## Report 04-03-00974 Rev. 0.00

DSB - Expert Assessment of IC4/2

## EXPERT ASSESSMENT REPORT IC4/2

figure 2-1: DSB Deployment plan for IC4 trainsets (A2, 015)

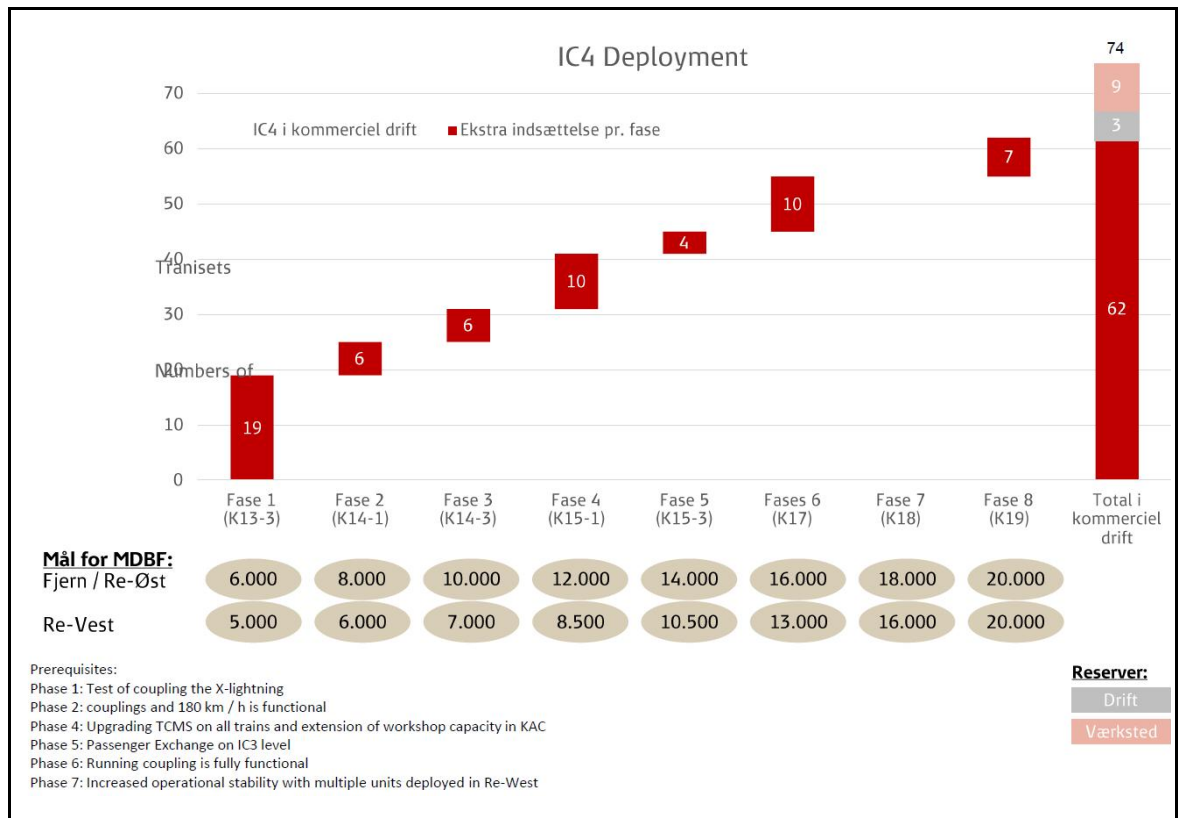
The provided deployment plan as per figure 2-1 contains three dimensions: Availability, Reliability and Functionality.

The final goal of 20,000 km MDBF regarding reliability is realistic in the long term in comparison with other vehicles and operators. Currently reliability is not given the same priority as availability and functionality. The MDBF baseline as an average of the fleet (January till August 2014) is 5,949 km for operation in regional and long distance traffic. The goal as per the deployment plan should be 7,260 km in January 2014 and increase to 9,077 km in August 2014. The total reliability improvement potential addressed is 2,473 km. This is not even sufficient to reach the goal defined for August 2014. However the MDBF of 13,687 km (A2, 406) only for November 2014 shows a positive tendency.

- The MDBF baseline calculated by RIT as average of the fleet (January till August 2014) is 5,949 km (A2, 161) for operation in regional and long distance traffic. The MDBF goal as per the deployment plan should be 7,260 km in January 2014 and increase to 9,077 km in August 2014 (A2, 015).

- Measures recommended
  - Plan to be maintained by owner
  - Goals must be monitored and communicated because they are partly unknown as determined during interviews with DSB Operation and in workshop KAC

figure 10-2: Overview of the coupler buffer with bearings yellow marked (7, 8) (A2, 159)

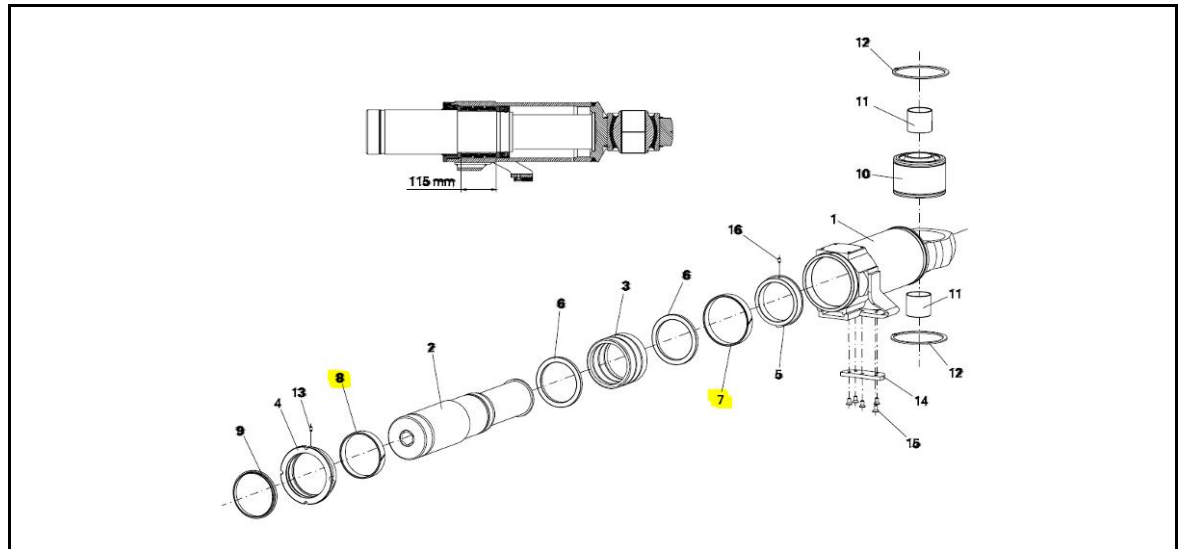
The extraction and retraction of the coupler is guided by two bearings (bushings) (7, 8 in figure 10-2) that are positioned between the buffer tube (1 in figure 10-2) and the hydraulic buffer (2 in figure 10-2) within the Dellner coupler.

In March 2014 DSB reports, that the outer diameter of the bearing is bigger than the inner diameter of the pipe, where the bearings are placed in (A2, 210).

Dellner stated that the bearing is oversized because of some expansion as the bearings have the potential to take on some moisture. Since the coupler has been placed for a longer time under unknown conditions, Dellner stated that the moisture could be the potential root cause (A2, 211).

figure 10-5: The new blending philosophy according to FT values (A2, 401)

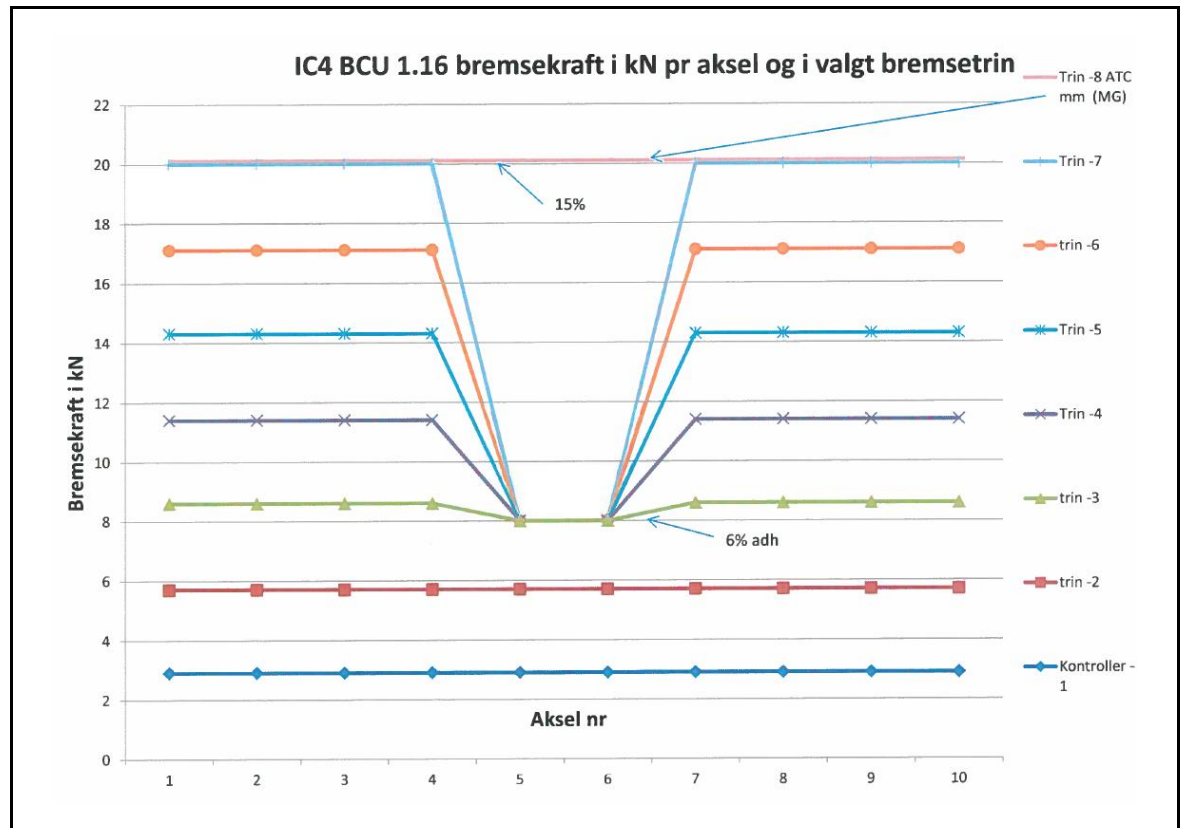
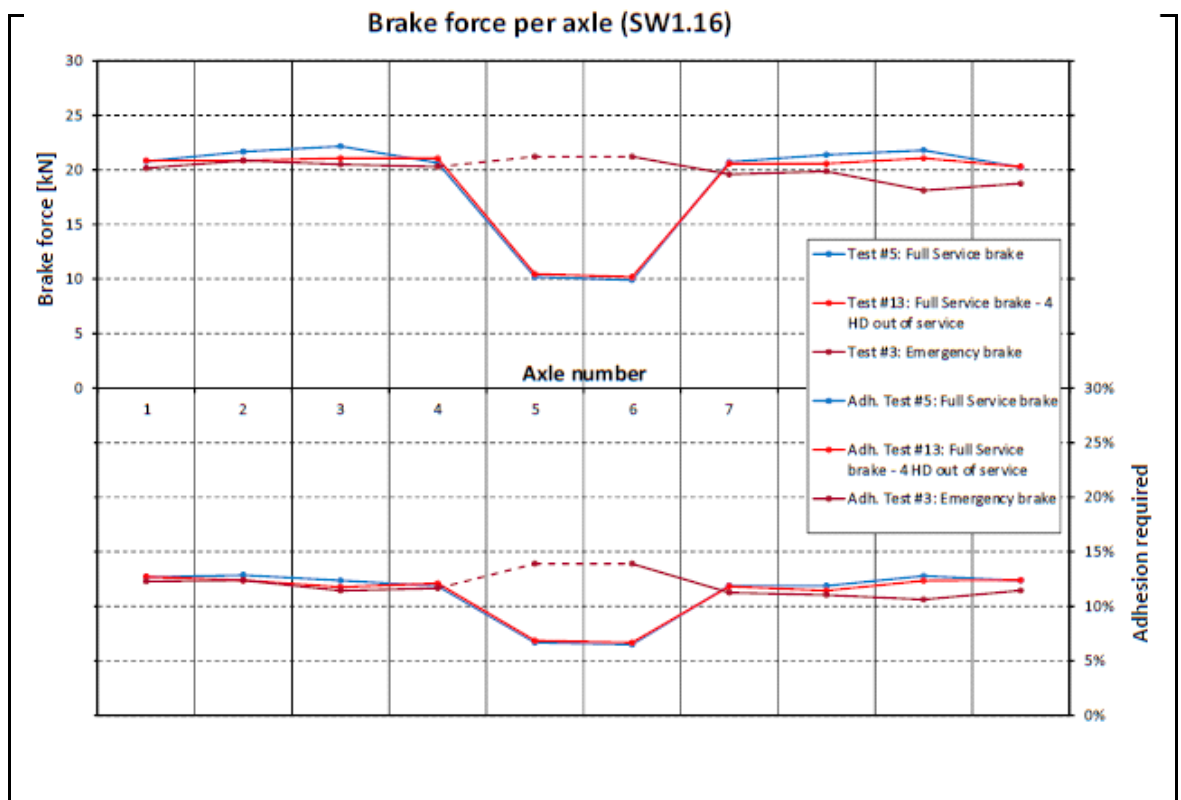
It has to be pointed out that the calculated brake force values may differ from the real values. Therefore a detailed analyse should be done by the IC4PT brake task force team with the exact values.

It can be noticed that the calculated brake force is not equally distributed between the axles as specified and required (figure 10-4):

Nevertheless, even if these variations don't have relevant consequences the question rises

- A validation plan of the new blending parameters in the BCU software has to be set up.
  - The brake system of the IC4/2 trainsets is complex with numerous monitoring equipment and redundancies. A deep investigation of the system is advised with the goal to identify the possibilities to increase the reliability of the system.

figure 10-6: Primary damper supports at the lower part of the axle box housing

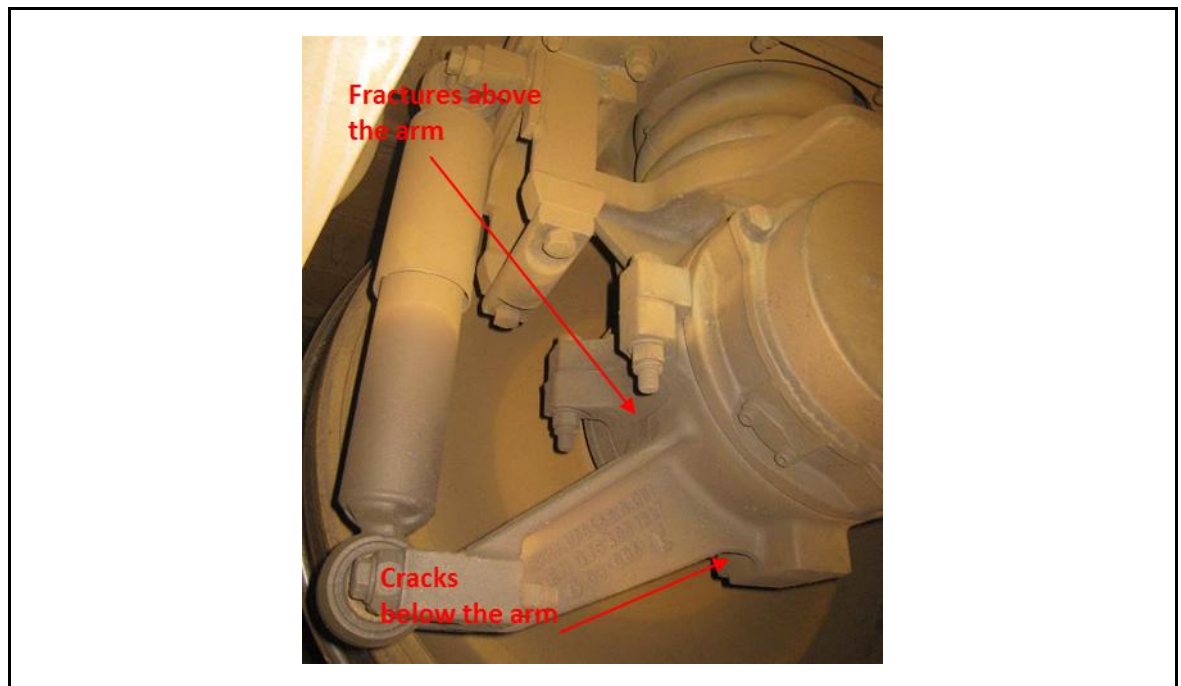
Cracks and fractures at the primary damper supports (figure 10-6) at the lower part of the axle box housing (herein after called “damper support”) is one of the main topics which has consumed a high amount of additional resources for inspection in the workshop. This prevents the achievement of the goals set by the deployment plan (A2, 015) primarily in respect to CFG implementation (MDBF performance).

4. Compliance is given to the currently conclusion that the bottom part in the area of the reinforcement under the arm of the damper support (figure 10-8) is the critical place for fatigue cracks in regard to maximum permissible stress level as the FEM analysis predicts (A2, 117). This is assigned to the 5 founded cracks at the damper supports in this area (A2, 340).

A strong indication for the finding above mentioned under 3. is given by the fact that there has been found three (3) broken damper supports over the arm close to the casting edge (figure 10-7) on the leading axles and 1 crack at the damper at the same place (support over the arm) on a driven axle (A2, 340).

figure 10-10: Rail guard mounting (A2, 352)

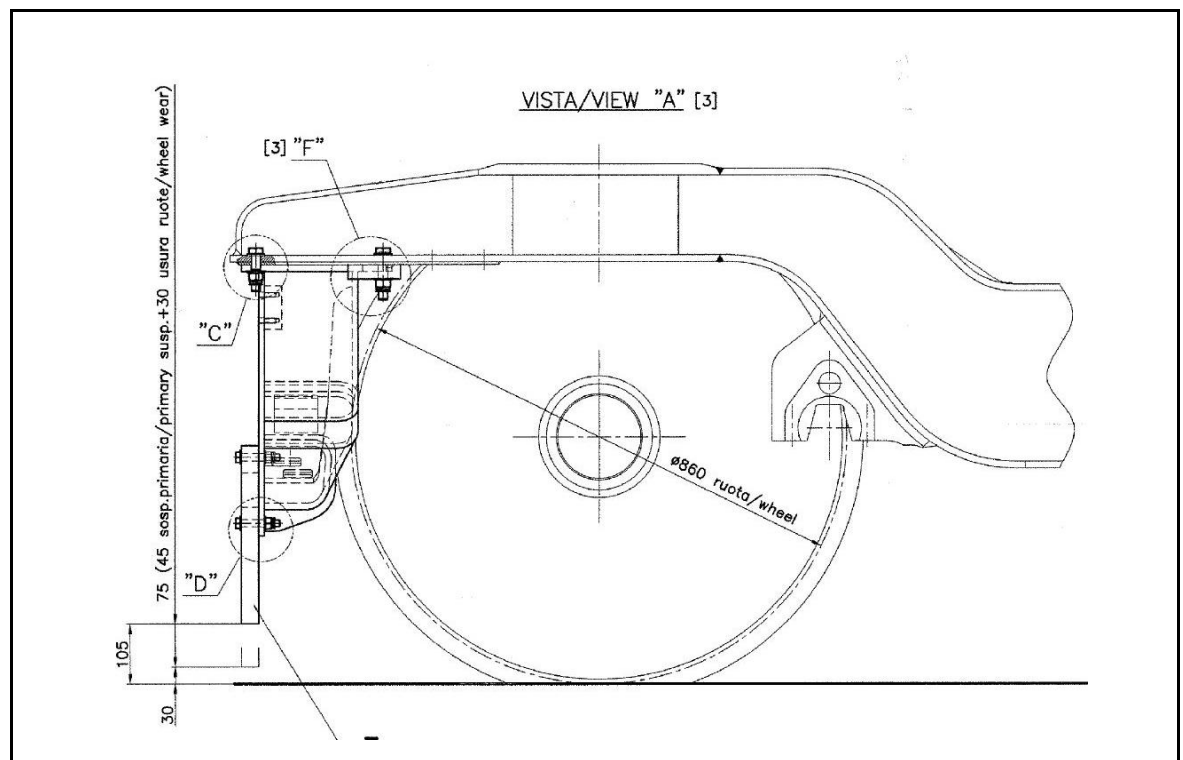
It has been stated that initial cracks may cause by obstacles on the track. This has not been avoided by the rail guard since this element is design for worn wheels and not for new wheels refer to figure 10-10. To avoid future collision with larger objects this rail guard can be lowered in such a way that the wear of the wheels can be corrected by shimming or similar.

To ensure that the out-of-roundness of 0.4 mm is under control the wheel maintenance manual should follow EN15313 which allowed a maximum of 0.3 for this type of trainset.

**figure 10-11:** Bolts for the mounting of the manifold close to the turbo charger (A2, 254)

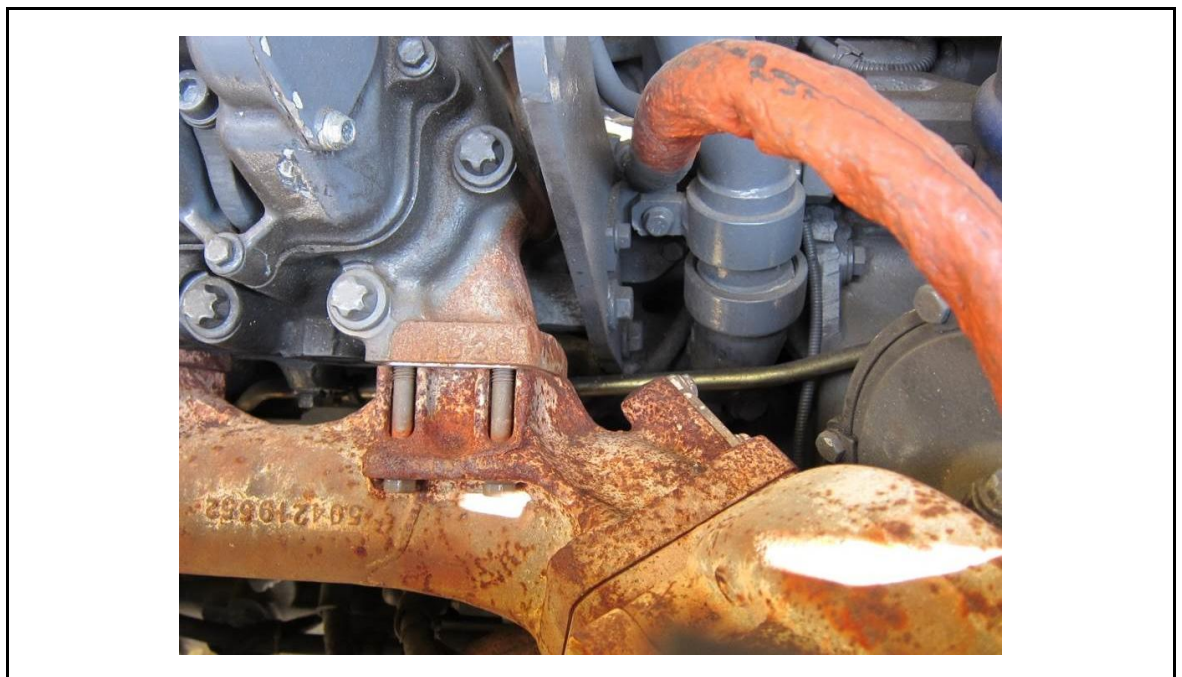
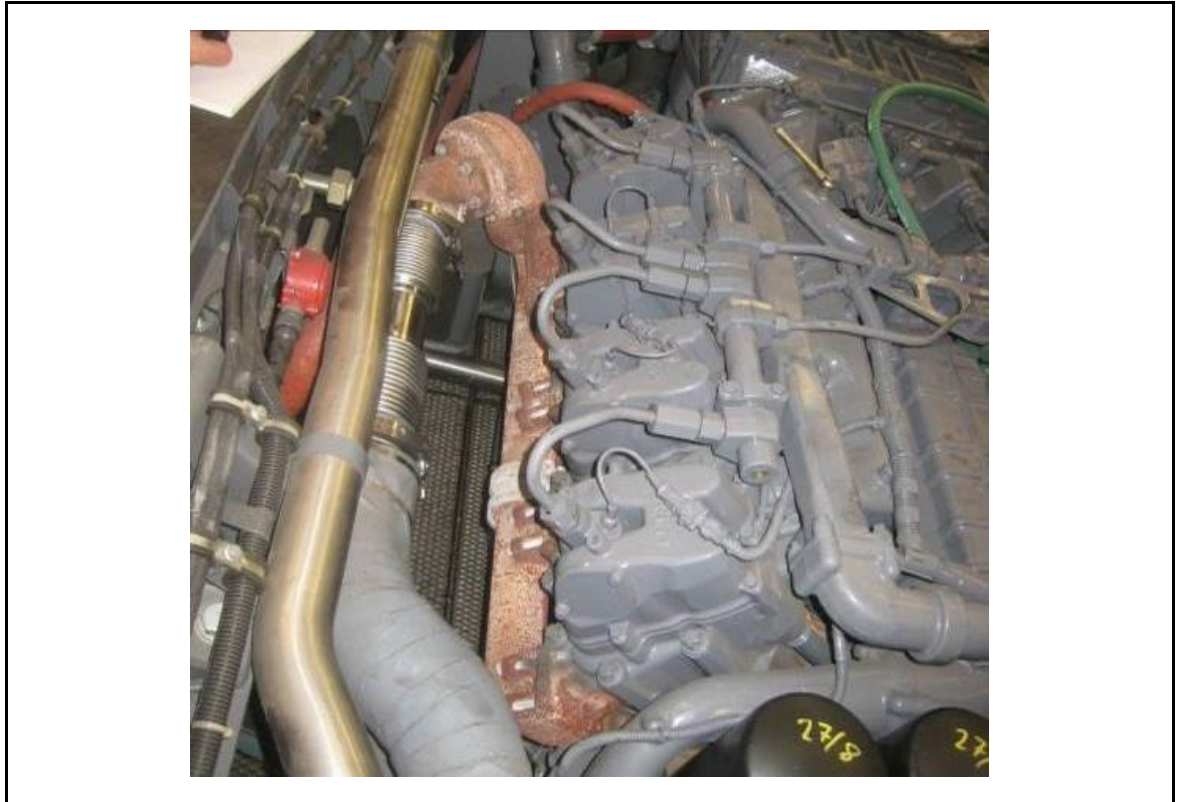
CFG-DSB0131 was opened in July 2012 because of broken bolts on the manifolds (A2, 254). The bolts are close to the turbo chargers on both sides of the motor.

The root cause has been quickly identified as being the weight of the turbo chargers that are eccentrically mounted, yet being only fixed by the manifolds. Due to the running dynamic loads on the turbo chargers, the manifolds and the bolts are highly stressed.

In June 2014 cracks have been found on the manifolds. The cracks are along a 45° line between the bolts and the turbo charger.

**figure 10-16:** Prototype based on FC510-08 hose from Aeroquip with the adapter for the connection to the high pressure pump (PROSE)

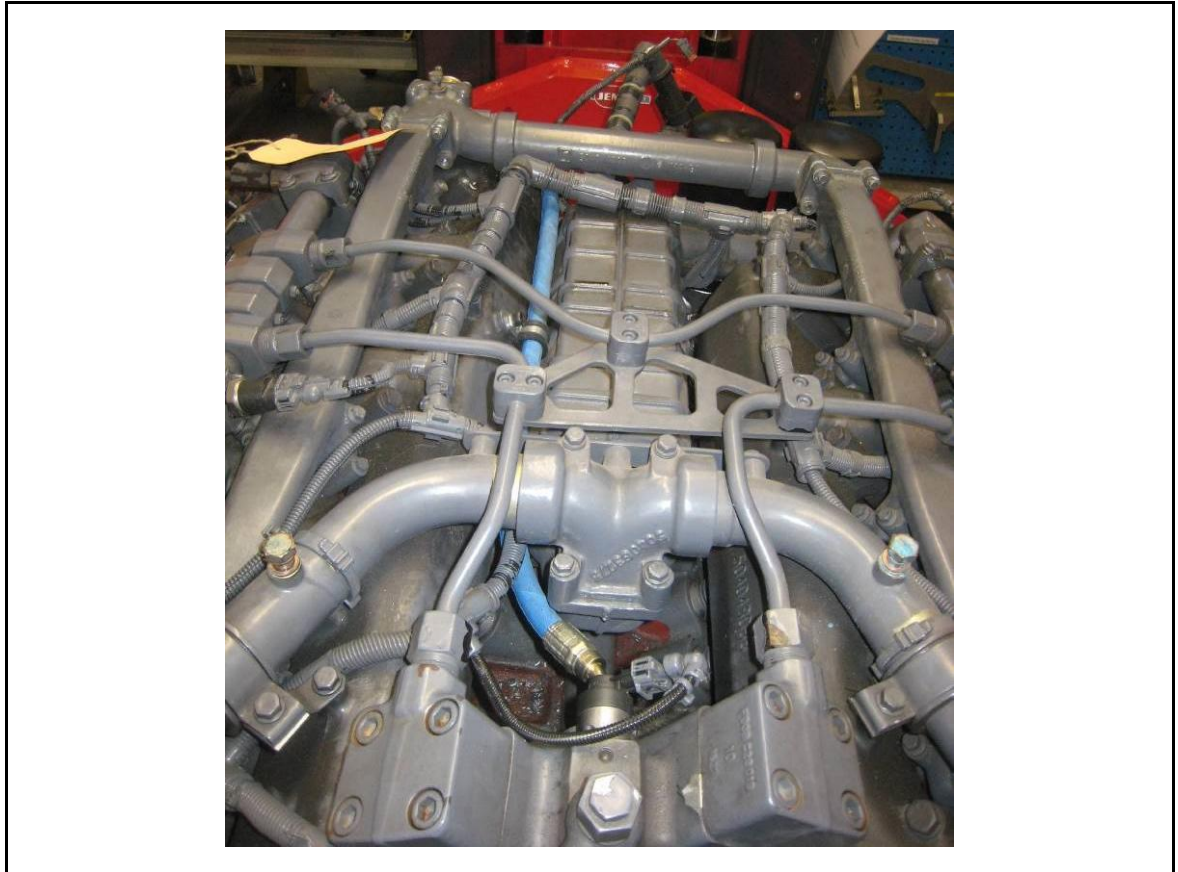
DSB performed a risk estimation considering the real frequency of the leakage with the result that the risk is undesirable (A2, 405). Therefore the risk estimation will be sent to DSB safety and mitigation actions have to be implemented.

DSB developed a first prototype of new fuel pipe based on the Aeroquip FC510 hose (FC510-08) (A2, 251/302). The hose is adapted to the application, withstanding fuel and lubrication with an operating temperature up to 150°C. The minimal acceptable bending radius of the pipe is 127mm, which is higher than the bending radius of the original pipe. Therefore an adapted connection has been designed by DSB.

A second prototype is developed based on the GH100-8 ESP hose from Aeroquip (A2, 304). The hose withstands operating temperature up to 150°C and is adapted for fuel and application with new synthetic oil. The minimal acceptable bending radius is 51mm, which is of advantage compared with the FC510 hose.

figure 10-17: Damaged radial thrust bearing: spalling, grooves and corrosion are visible (PROSE)

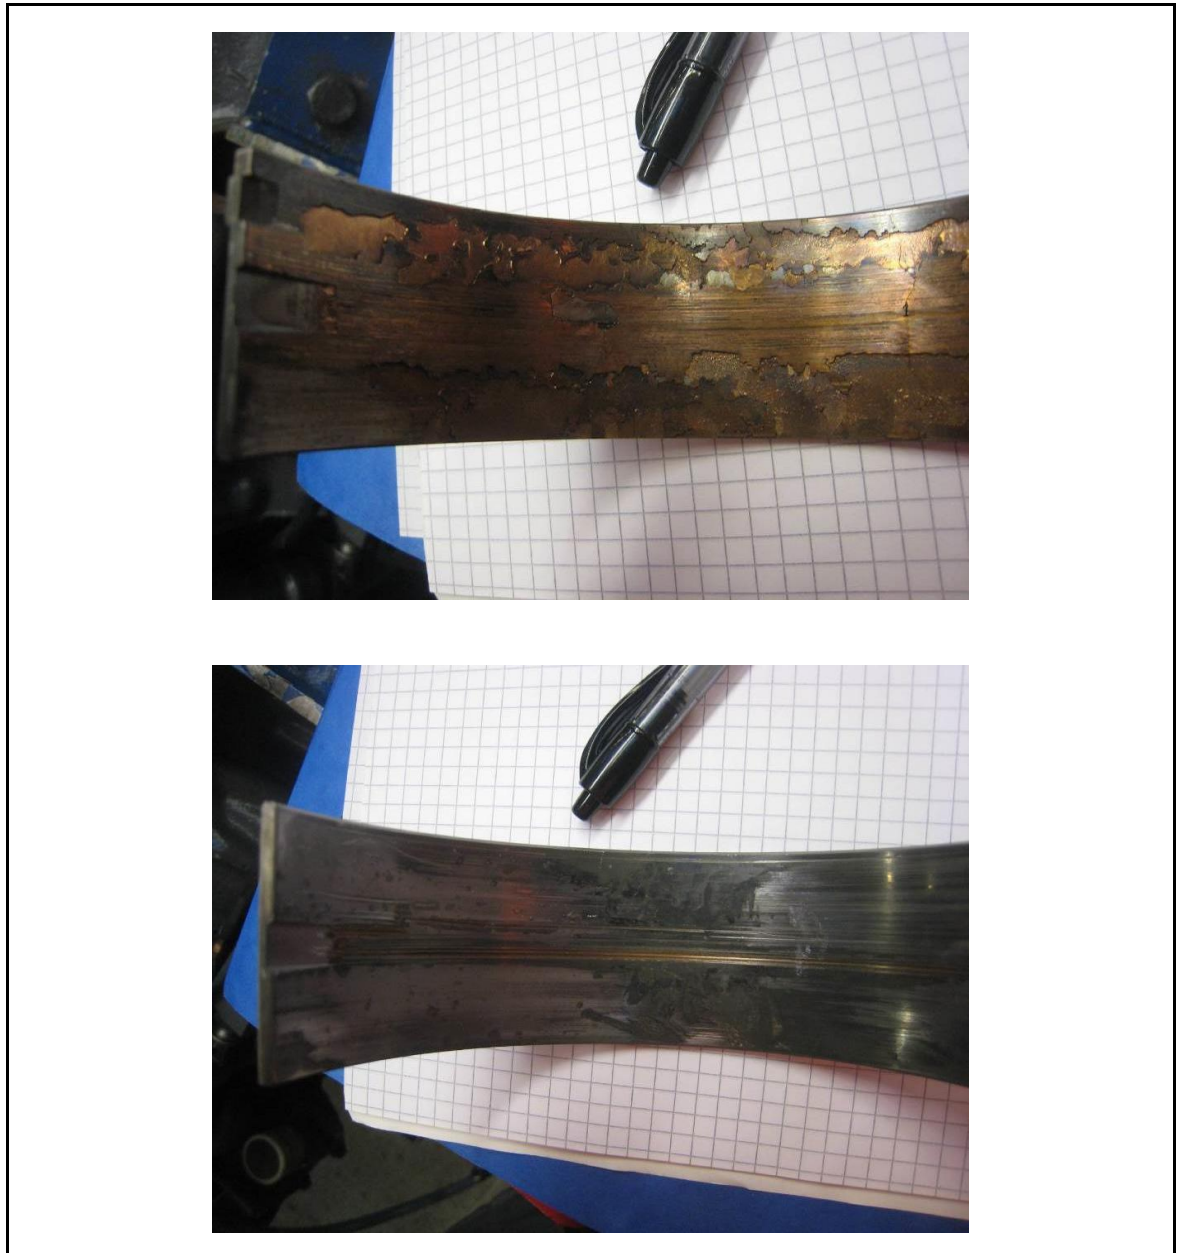
An investigation of the problem is mandatory to answer the question if the root cause of all these breakdowns is specific to these 5 motors (specific operation or specific conditions like long time parking) or if the root cause is a failure in the design potentially impacting the whole fleet (lack of lubrication or too high loads). The former could be handled by the IC4 program with an accurate action plan. The latter may rapidly lead to high costs for the implementation of a design change and may become a major issue for the outcome of the IC4 program and the fulfillment of the deployment plan.

DSB started the technical investigation but it appears that the investigation is delayed because of the lack of available resources. The technical and financial risks connected to these breakdowns cannot be estimated today.

PROSE recommends the implementation of a task force to assess the risk of a design failure and to define the specific corrective actions.
